# UNITED STATES PATENT AND TRADEMARK OFFICE

APPLICATION NO.	FILING DATE	FIRST NAMED INVENTOR	ATTORNEY DOCKET NO.	CONFIRMATION NO.
10/679,289	10/07/2003	Hiroaki Nemoto	HITA.0443	4034

<b>Office Action Summary</b>	<b>Application No.</b> 10/679,289	<b>Applicant(s)</b> NEMOTO, HIROAKI	
	<b>Examiner</b> Paul D. Kim	<b>Art Unit</b> 3729

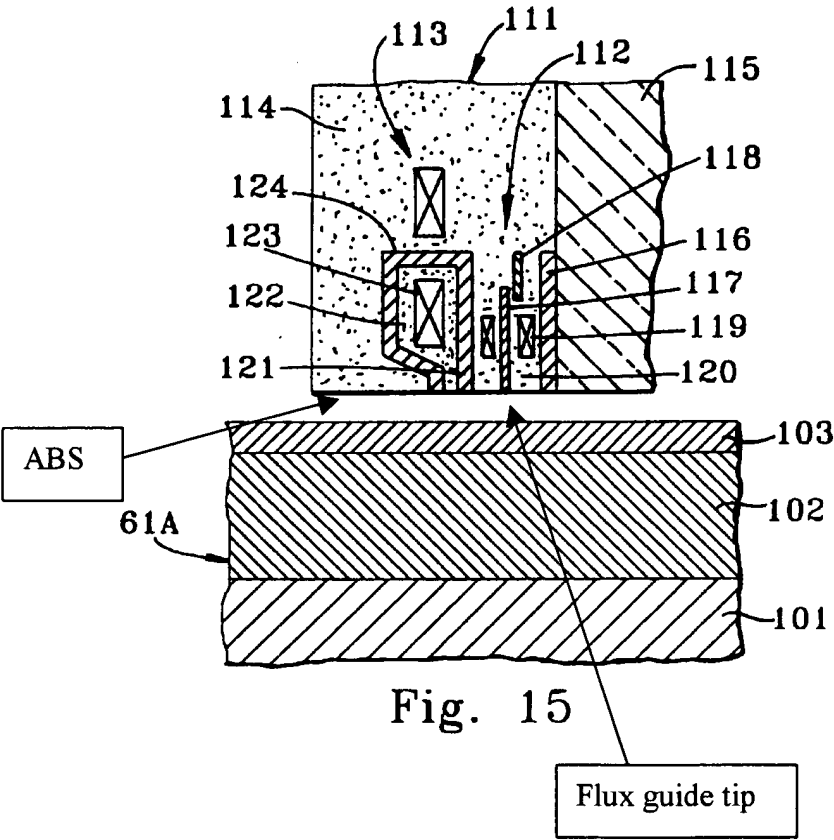
Fig. 15 of Takada et al. teach a process of making a magnetic head comprising steps of: forming a lower non-magnetic film (equivalent with an insulating film, 114) over a substrate (115); forming a lower gap film (120) over the lower non-magnetic film; forming a flux guide (117) and an MR element (118); forming an upper gap film (equivalent with an insulating film, 114) over the flux guide and MR element; and forming magnetic shields (116) wherein at least the magnetic shield part is formed on a basic surface of the magnetic head (111) opposite a magnetic recording medium (61A), and a height of the magnetic shields appears to be less than a distance from the air bearing surface to the MR element as shown in Fig. 15 (see also col. 12, lines 7-37), wherein Takada et al. teach that the flux guide and MR element are embedded in the insulating film (114).

According to Fig. 15 of Takada et al., the magnetic head is flattened by the air bearing surface opposite to the magnetic recording medium. However, Takada et al. do not describe how to form the surface is flattened. APA teaches a process of forming a magnetic head including a process of grinding a slider (equivalent with a magnetic head element) to determine the air bearing surface as shown in Fig. 1E (paragraph [13], lines 15-21). It is meant that the head element is cut and machined or ground into the air
